**BOARD OF HEALTH AGENDA
THURSDAY, MAY 29, 2014 SPECIAL MEETING
CITY-COUNTY COMPLEX/EAST ROOM**

Two Suns Farms Variance Request

To: Park City-County Board of Health
From: Barbara Woodbury, R.S., M.P.H. *BW*
RE: Waiver Requests from Two Suns Farm, 3158 East River Rd, Park County, MT

**RE: Request of Waiver Closed Component Setbacks
Two Suns Farms Wastewater Treatment System
3158 East River Road, Located in a portion of the W ½, Sec. 1, T3S, R9E, P.M.M.
Park County, Montana**

FIGURE
S-0

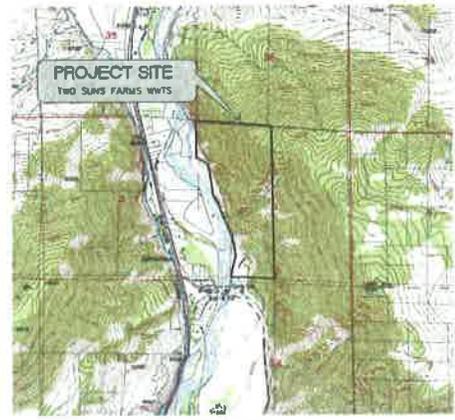
- 1) Waiver from 50 ft. Horizontal Setback to Other Wells The setback between the forcemain and a water well cannot be maintained. They are proposing 44.6 ft. versus 50 ft. separation. The section of the forcemain that is less than 50 ft. will be sleeved as extra precaution from possible contamination.

- 2) Waiver from 10-ft. Horizontal Setback to Foundation Walls The proposal is to run the forcemain under the accessory building, therefore less than 10 ft. to the foundation. They are proposing sleeving this portion of the forcemain to allow for access and repairs in the future.

- 3) Waiver from 50-ft. Horizontal Setback to Surface Water The only location to run the forcemain to the southern portion of the property is to go along the road. There is no other way to run the line. 50 ft. setback to the surface water cannot be maintained---there is not enough room between the surface water and the mountain side to allow for the full 50ft setback. Once again they are proposing to sleeve this section of the forcemain as a protective measure to protect the surface water in case the forcemain should ever break.

- 4) Waiver from 10ft-Horizontal Setback to a Water Line Again, the constraints of the property make it impossible to meet the setbacks. Any portion of forcemain not meeting the setback will be sleeved to protect the water line from contamination.

1. Waiver from 50-ft Horizontal Setback to Other Wells: the minimum horizontal setback required from an "other well" to a closed component is 50-ft. Currently, there are two water supply wells located just to the north of the stone cellar building (proposed to be remodeled into a 1-bedroom accessory building). The existing water supply well to the east is a hand dug well that was completed in the early-to-mid 1900's. The western existing water supply well was subsequently drilled and is planned to service the existing home and the proposed 1-bedroom accessory building. The existing hand dug well is proposed to be properly abandoned once the existing home and proposed accessory building become connected to the "newer" existing well.

At its nearest point, the proposed forcemain is approximately 44.6' from the "newer" existing water supply well to the west. Due to the existing site conditions, the proposed alignment of the forcemain provides the greatest separation from the "newer" water well. The section of sanitary sewer pipe less than 50-ft from a well will be sleeved.

2. Waiver from 10-ft Horizontal Setback to Foundation Walls: the minimum horizontal setback required from a foundation wall to a closed component is 10-ft. From the conditions outlined in the Request of Waiver From 50-ft Horizontal Setback to an Other Well, the alignment best suited for this project (as shown on the plans), is to run the forcemain underneath the proposed 1-bedroom accessory building. The forcemain will be sleeved for protection and future access.

3. Waiver From 50-ft Horizontal Setback to Surface Water: the minimum horizontal setback required from surface water to a closed component is 50-ft. Currently, the existing single family home is located near the northern end of the subject property. Due to the delineated location of the floodplain and other setbacks, the only adequate location for an absorption system is located near the southern end of the subject property. The only feasible means to pump effluent from the existing home location to the proposed absorption system area is to follow the existing driveway that is located adjacent to the Yellowstone River. From this, the proximity of the proposed forcemain to the river is less than the required 50 horizontal feet. The section of forcemain less than 50-ft from surface water will be sleeved.

4. Waiver From 10-ft Horizontal Setback to a Water Line: the minimum horizontal setback required from a water line to a closed component is 10-ft. Currently, the existing single family home is located near the northern end of the subject property and the best location for a domestic water supply well (quantity of yield and quantity of water) is located near the southern portion of the subject property. Due to existing site conditions including proximity to the Yellowstone River and existing mountainside with excessive slopes, the existing driveway is the singular corridor available to install utilities and services. From this, the available area to install dry utilities and services provides less than the required 10 horizontal feet from sanitary sewer closed components and water lines. The section of forcemain less than 10-ft from a water line will be sleeved.

As stated for each waiver, any section of sanitary sewer pipe not meeting setbacks will be sleeved. We are proposing a 3-inch diameter HDPE DR9 fused joint forcemain (200 psi pipe) that will be encased in a 6-inch diameter PVC pipe in all locations where the setbacks to closed components (Items #1 - #4) cannot be met. It is our opinion that the aforementioned configuration is best suited for the project, and adequately protects the health safety, and welfare of the environment.

Jon Mann moved to approve Wavier #1 for the variance with consideration to 1) the strict application of regulations would result in extreme difficulty or undue hardship to the applicant; 2) the applicant provided sufficient evidence demonstrating the proposal for a variance would not be detrimental to the purposes of these regulations; 3) the variance proposed is the minimum variation which would alleviate the specified practical difficulty as found by the Park County Board of Health. All conditions should apply to the request for all four variations. Four variations include: waiver from 50-foot horizontal setback from other wells; waiver from 10-foot horizontal setback to foundation walls; waiver from 50-foot horizontal setback from surface water; 10-foot horizontal setback to water line. Rusty Collyer seconded the motion. Motion passed unanimously.

- Staff recommends approval of all proposed waiver requests.
